Subject: Issuance of Amendment No. 4 to Facility Operating License NPF-10
San Onofre Nuclear Generating Station, Unit 2

SAN ONOFRE NUCLEAR GENERATING STATION, UNIT 2

Amendment No. 4
License No. NPF-10

Replace the following pages of the Appendix A Technical Specification with enclosed pages. The revised pages are identified by Amendment number and contain vertical lines indicating the area of change. The corresponding overleaf pages are also provided to maintain document completeness.

Figure 3.1-1

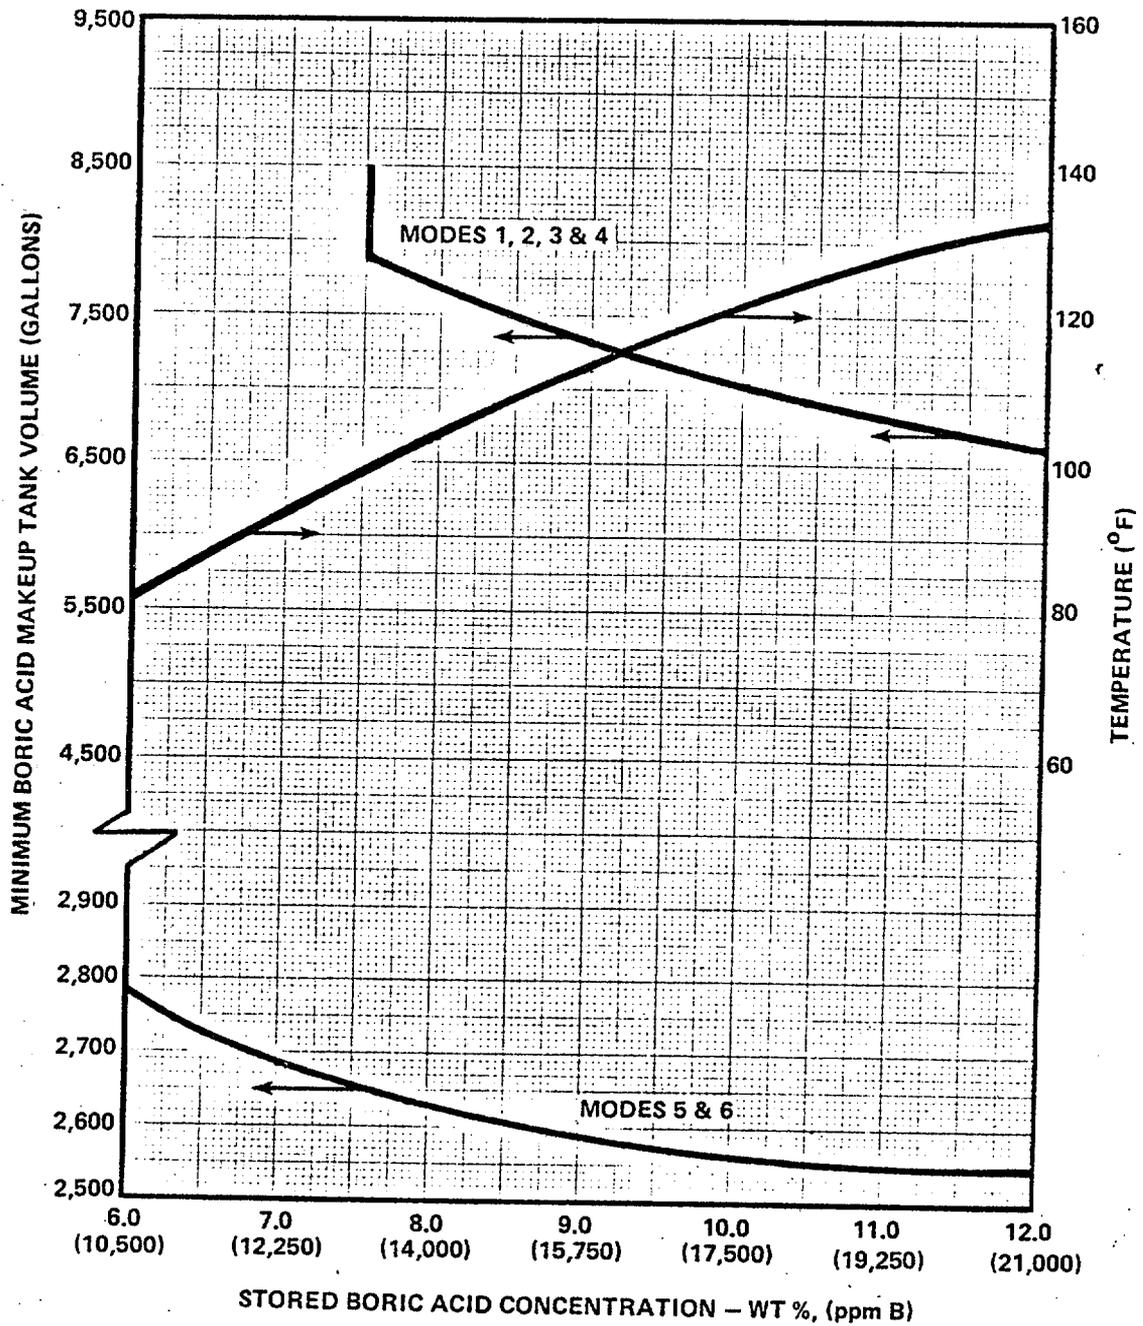
In Technical Specifications Sections 3.1.2.7.b.3 and 3.1.2.8.b.3, the licensee proposes to change the required refueling water storage tank temperature from "a solution temperature between 40F and 120F" to "a solution temperature between 40F and 100F, " for consistency with Technical Specification 3/4.5.4.

This is a change in the direction of greater conservatism since it restricts the allowable temperature range. The change also results in greater consistency between sections and is therefore approved.

Figure 6.2-2 Unit Organization, San Onofre Nuclear Generating Station-Unit 2

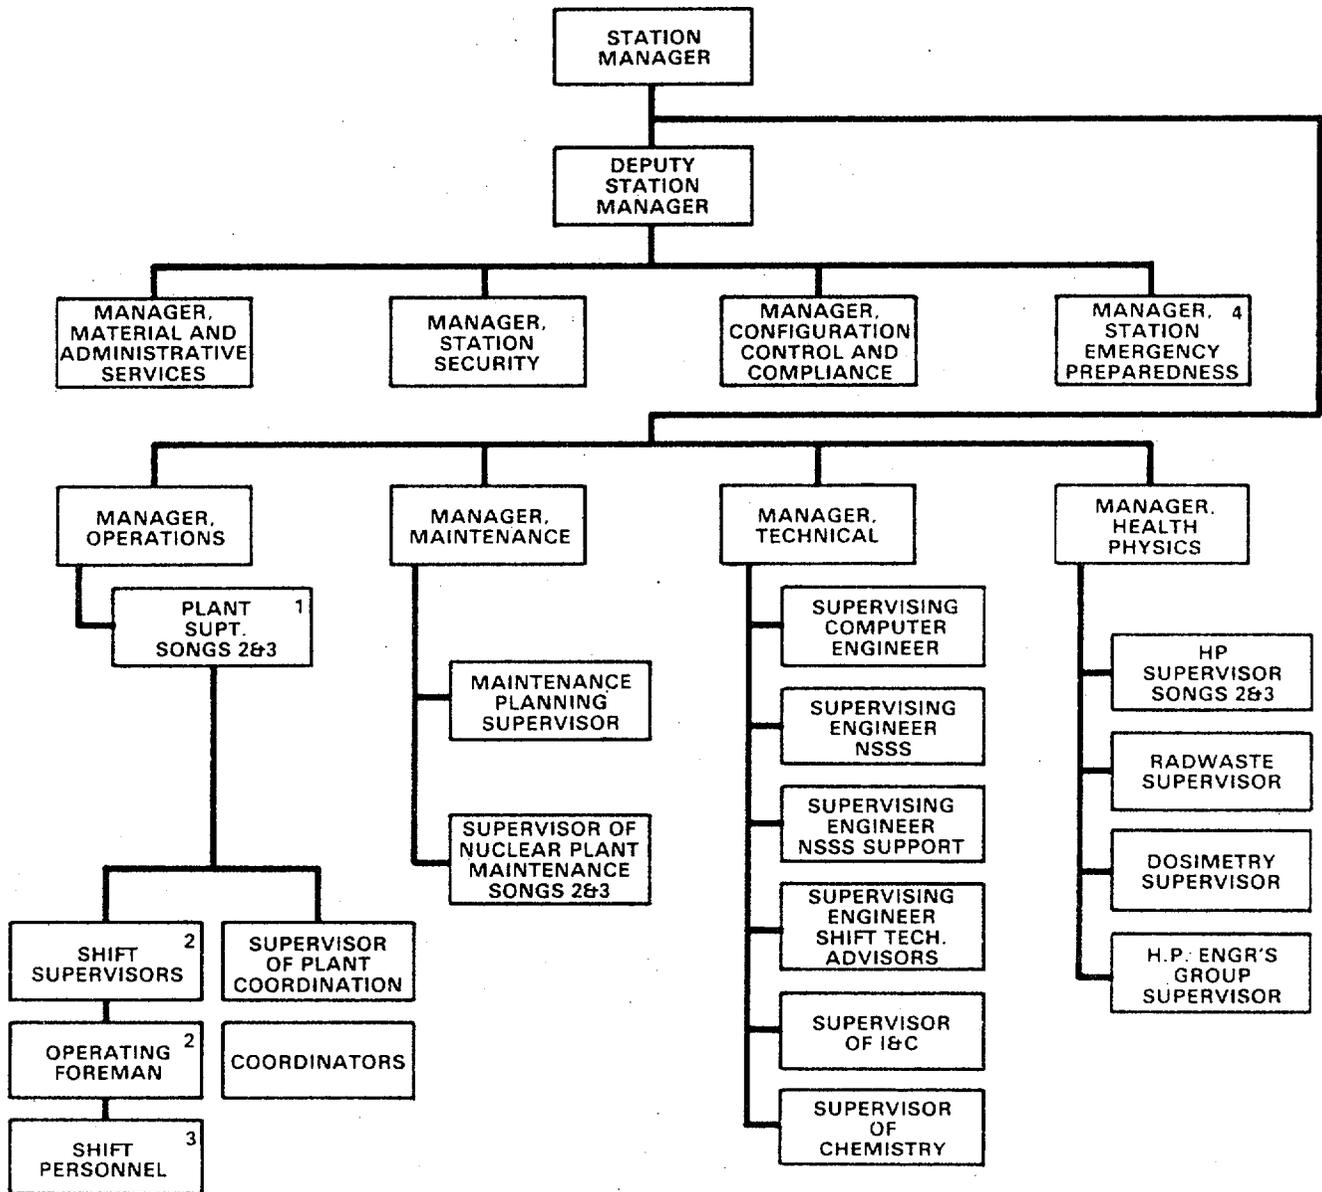
Change Technical Specification S 6.1-2, 6.2-2, Table 6.2-1, Figure 6.2-2 and Figure 6.2-3 to reflect current personnel titles.

The proposed changes to Figure 6.2-2 are primarily changes in position titles, as is suggested by the Licensee's description of the change. The inclusion of note 4 merely clarifies the fact that the Manager, Station Emergency Preparedness, is responsible for plant fire protection. There is no safety significance in these changes or in the deletion of the administrative position of Supervisor, Planning and Budgeting, under the Deputy Station Manager. Therefore, these changes are acceptable.

figure 6.2-3

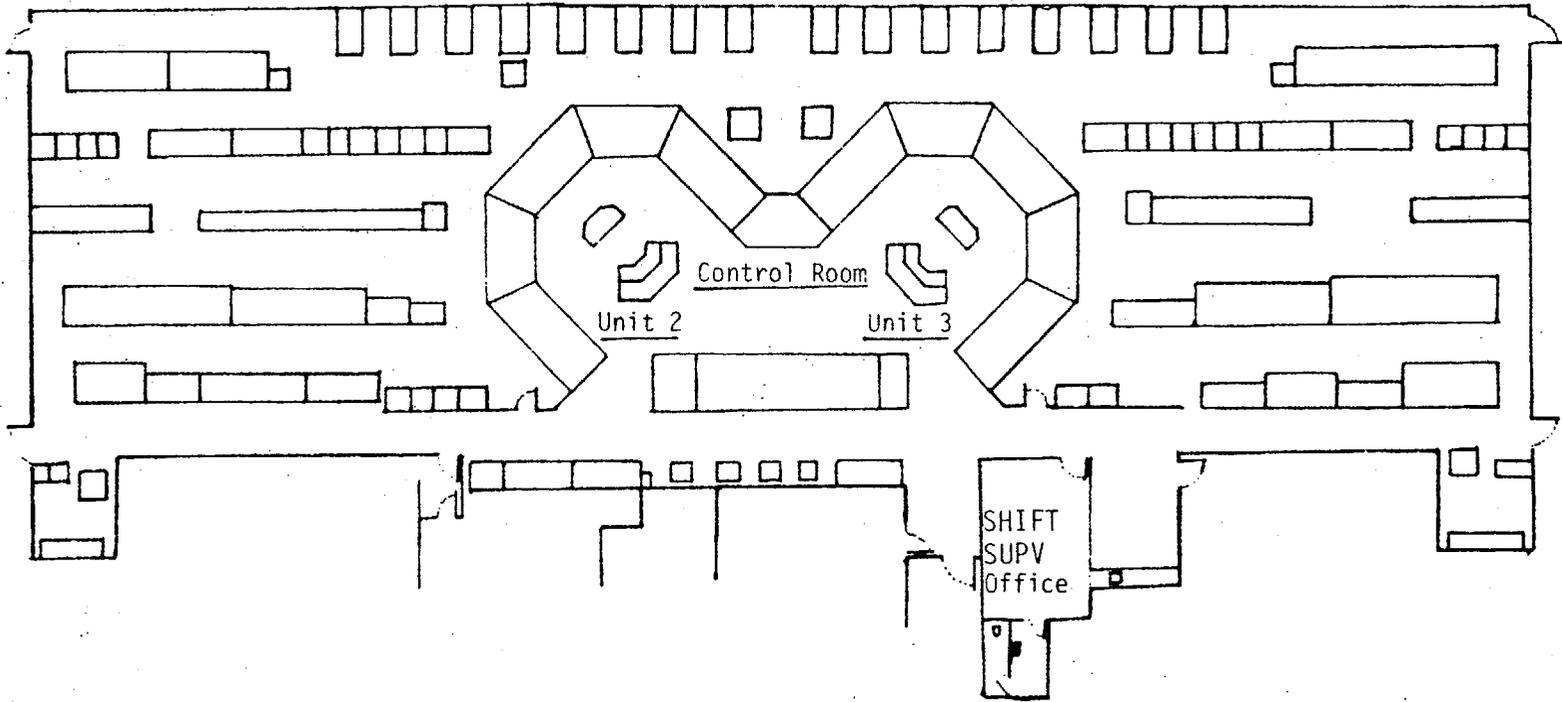
The proposed changes to Technical Specifications 6.1.2, 6.2.2.e, Table 6.2-1 and Figure 6.2-3 are of no safety significance and are acceptable because they only change the "Watch Engineer" position title to "Shift Supervisor."
